#### **Addendum 116 – UN Regulation No. 117**

#### **Revision 4 - Amendment 6**

Supplement 14 to the 02 series of amendments – Date of entry into force: 8 October 2022.

#### **Uniform provisions concerning the approval of tyres with regard to rolling sound emissions and/or to adhesion on wet surfaces and/or to rolling resistance**

## "Annex 2 - Appendix 1

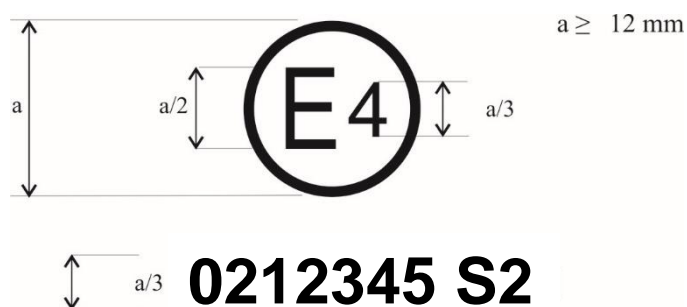
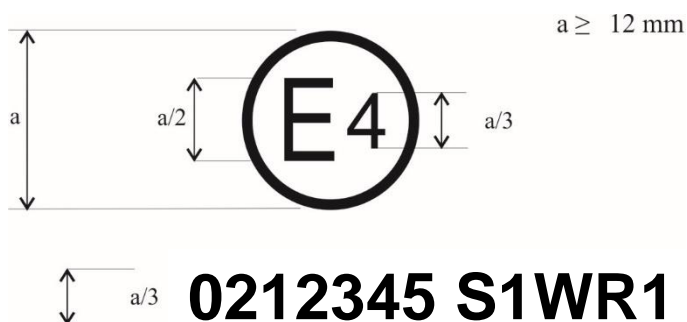
Annex 2 - Appendix 1, amend to read:

The above approval mark, affixed to a tyre shows that a tyre concerned has been approved in the Netherlands (E 4) pursuant to Regulation No. 117 (marked by "S2"), under approval number 0212345. This indicates that the approval is for rolling sound at stage 2 (S2). The first two digits of the approval number (02) indicate that the approval was granted in accordance with this Regulation which included 02 series of amendments.

The above approval mark shows that the tyre concerned has been approved in the Netherlands (E 4) pursuant to Regulation No. 117 (marked by "S1WR1") under approval number 0212345. This indicates that the approval is for rolling sound at stage 1 (S1), wet adhesion (W) and rolling resistance at stage 1 (R1). The first two digits of the approval number ("02") indicate that the approval was granted in accordance with this Regulation which included the 02 series of amendments."

## "Annex 2 - Appendix 2

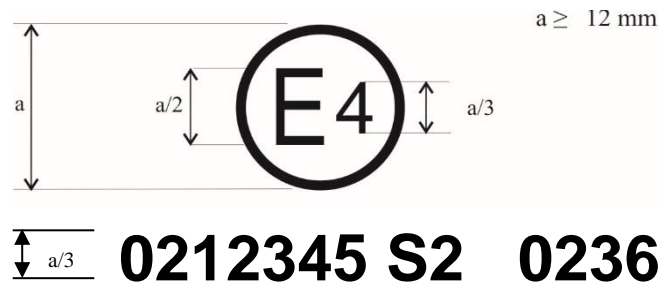
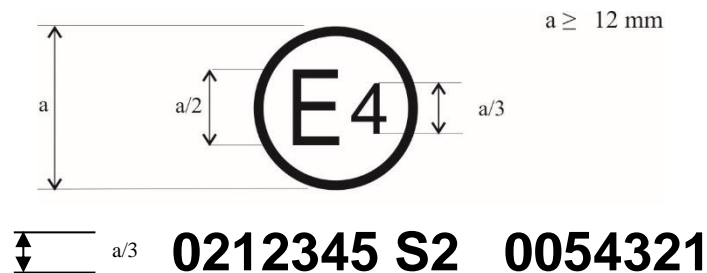
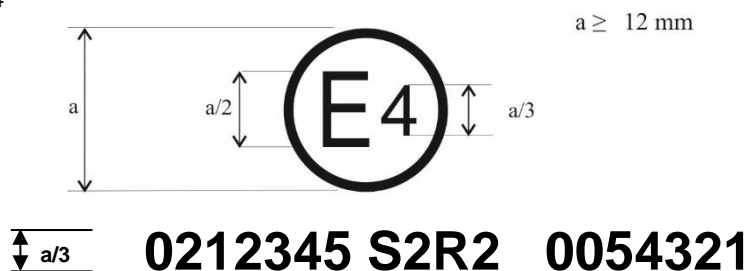
Annex 2 - Appendix 2, delete footnote 1 and amend to read:

The above approval mark shows that the tyre concerned has been approved in the Netherlands (E 4) pursuant to UN Regulation No. 117 (marked by "S2"), under approval number 0212345 and UN Regulation No. 30, under approval number 0236378. This indicates that the approval is for rolling sound at stage 2 (S2). The first two digits of the approval number ("02") in conjunction with "S2" indicate that the approval was granted in accordance with UN Regulation No. 117 which included the 02 series of amendments. The first two digits of the UN Regulation No. 30 approval number ("02") indicate that this Regulation included the 02 series of amendments.

The above approval mark shows that the tyre concerned has been approved in the Netherlands (E 4) pursuant to UN Regulation No. 117 (marked by "S2WR2"), under approval number 0212345 and UN Regulation No. 30, under approval number 0236378. This indicates that the approval is for rolling sound at stage 2 (S2), wet adhesion (W) and rolling resistance at stage 2 (R2). The first two digits of the approval number ("02") in conjunction with "S2WR2" indicate that the first approval was granted in accordance with UN Regulation No. 117 which included the 02 series of amendments. The first two digits of the UN Regulation No. 30 approval number ("02") indicate that this Regulation included the 02 series of amendments.

The above approval mark shows that the tyre concerned has been approved in the Netherlands (E 4) pursuant to UN Regulation No. 117 and the 02 series of amendments under approval number 0212345 (marked by "S2"), and UN Regulation No. 54, under approval number 0054321. This indicates that the approval is for rolling sound stage 2 (S2). The first two digits of the UN Regulation No. 117 approval number ("02") in conjunction with "S2" indicate that the first approval was granted in accordance with UN Regulation No. 117 which included the 02 series of amendments. The first two digits of the UN Regulation No. 54 approval number ("00") indicate that this Regulation was in its original form.

The above approval mark shows that the tyre concerned has been approved in the Netherlands (E 4) pursuant to UN Regulation No. 117 and the 02 series of amendments under approval number 0212345 (marked by "S2R2"), and UN Regulation No. 54, under approval number 0054321. This indicates that the approval is for rolling sound stage 2 (S2) and rolling resistance stage 2 (R2). The first two digits of the UN Regulation No. 117 approval number ("02") in conjunction with "S2R2" indicate that the first approval was granted in accordance with UN Regulation No. 117 which included the 02 series of amendments. The first two digits of the UN Regulation No. 54 approval number ("00") indicate that this Regulation was in its original form."

## "Annex 2 - Appendix 3

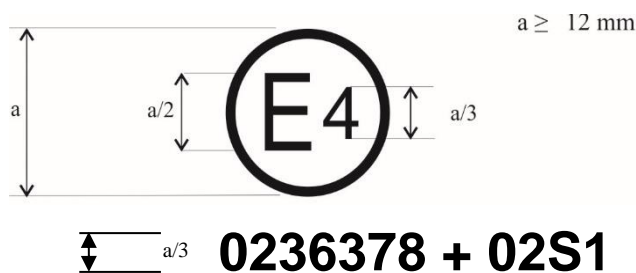
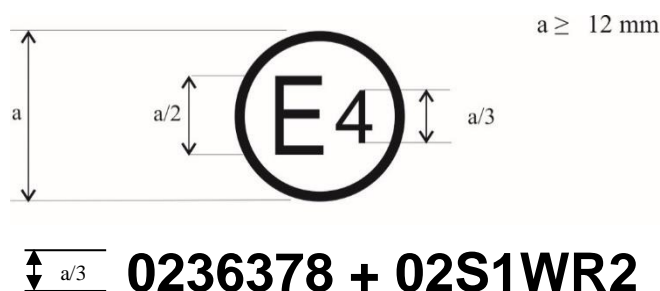
Annex 2 - Appendix 3, amend to read:

The above approval mark shows that the tyre concerned has been approved in the Netherlands (E 4) pursuant to UN Regulation No. 30 according to its 02 series of amendments (indicated by the first two digits of the approval number, "02") under approval number 0236378. It is also marked by "+ 02S1" which indicates that the tyre was also approved pursuant to UN Regulation No. 117 (02 series of amendments) for rolling sound at stage 1.

The above approval mark shows that the tyre concerned has been approved in the Netherlands (E 4) pursuant to Regulation No. 30 according to its 02 series of amendments (indicated by the first two digits of the approval number, "02") under approval number 0236378. It is also marked by "+ 02S1WR2" which indicates that the tyre was also approved pursuant to UN Regulation No. 117 (02 series of amendments) for S1 (rolling sound at stage 1), W (wet adhesion) and R2 (rolling resistance at stage 2)."

## "Annex 2 - Appendix 4

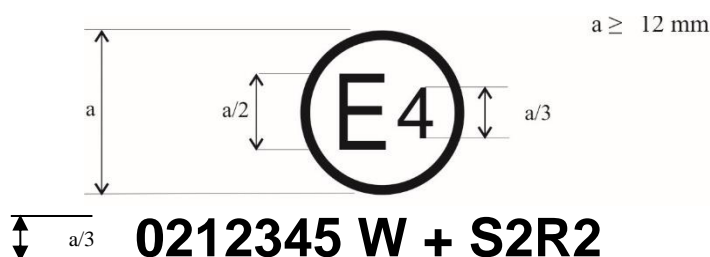
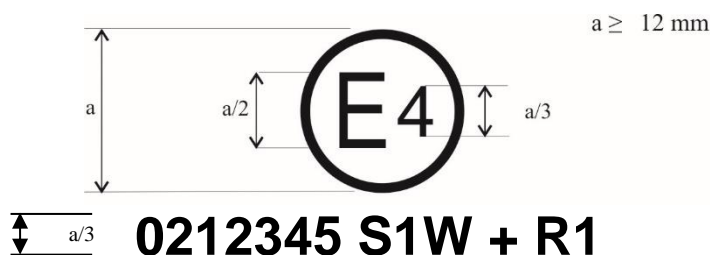
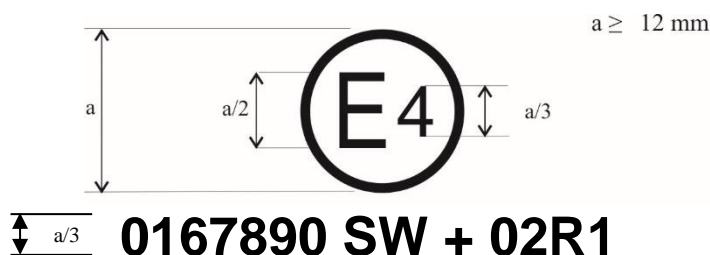
Annex 2 - Appendix 4, delete footnote 1 amend to read:

The above approval mark shows that the tyre concerned has been initially approved in the Netherlands (E 4) pursuant to UN Regulation No. 117 according to its 02 series of amendments (indicated by the first two digits of the approval number, "02") under approval number 0212345 (marked by "W"). This indicates that the approval is for W (wet adhesion). The "S2R2" preceded by "+" indicates that its approval has been extended under UN Regulation No. 117 to rolling sound at stage 2 and rolling resistance at stage 2 based on separate certificate(s).

The above approval mark shows that the tyre concerned has been initially approved in the Netherlands (E 4) pursuant to UN Regulation No. 117 according to its 02 series of amendments (indicated by the first two digits of the approval number, "02") under approval number 0212345 (marked by "S1W"). This indicates that the approval is for S1 (rolling sound at stage 1) and W (wet adhesion). The "R1" preceded by "+" indicates that its approval has been extended under Regulation No. 117 to rolling resistance at stage 1 based on separate certificate(s).

The above approval mark shows that the tyre concerned has been initially approved in the Netherlands (E 4) pursuant to UN Regulation No. 117 according to its 01 series of amendments (indicated by the first two digits of the approval number, "01") under approval

number 0167890 (marked by "SW"). This indicates that the approval is for S (rolling sound at stage 1) and W (wet adhesion). The "02R1" preceded by "+" indicates that its approval has been extended under UN Regulation No. 117 according to its 02 series of amendments to rolling resistance at stage 1 based on separate certificate(s)."
